NINE MILE POINT NUCLEAR STATION, UNIT NO. 1

Amendment No. 39
License No. DPR-63

ATTACHMENT TO LICENSE AMENDMENT NO. 39

Revise Appendix A as follows:

Figure 3.1.7.
NINE MILE POINT UNIT 1
LIMITING POWER FLOW LINE

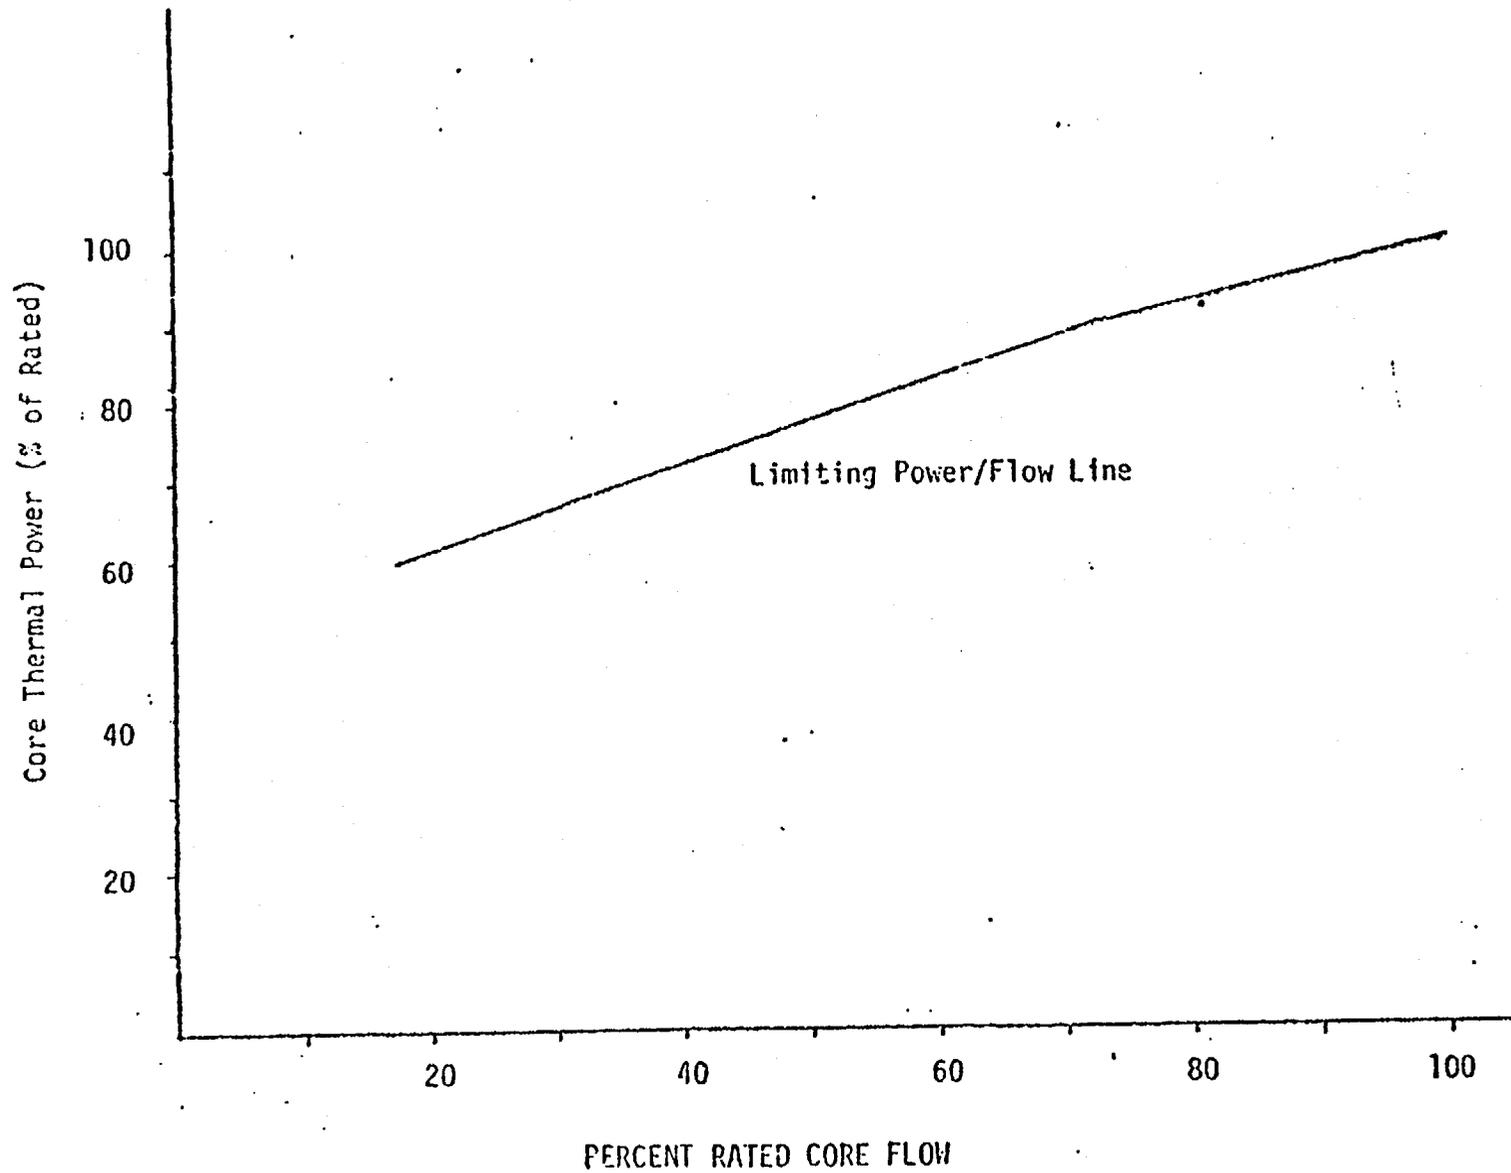
The power/flow relationship shall not exceed the limiting values shown in Figure 3.1.7.aa.

When operating with three or more recirculation loops in operation and the remaining loops unisolated, the reactor may operate at 100 percent of full licensed power level in accordance with Figure 3.1.7aa. No reduction in the APLHGR for each fuel type is required.

When operating with four recirculation loops in operation and one loop isolated, or with three recirculation loops in operation and one loop isolated and the remaining loop unisolated, the reactor may operate at 100 percent of full licensed power in accordance with Figure 3.1.7aa and an APLHGR not to exceed 98 percent of the limiting values shown in Figures 3.1.7a, 3.1.7b, and 3.1.7c, provided the following conditions are met for the isolated loop.

When operating with three recirculation loops in operation and the two remaining loops isolated, the reactor may operate at 100 percent of full licensed power in accordance with Figure 3.1.7aa and an APLHGR not to exceed 96 percent of the limiting values shown in Figures 3.1.7a, 3.1.7b, and 3.1.7c, provided conditions 1 and 2 above are met for the isolated loops. If these conditions are not met, core power shall be restricted to 90.5 percent of full licensed power.
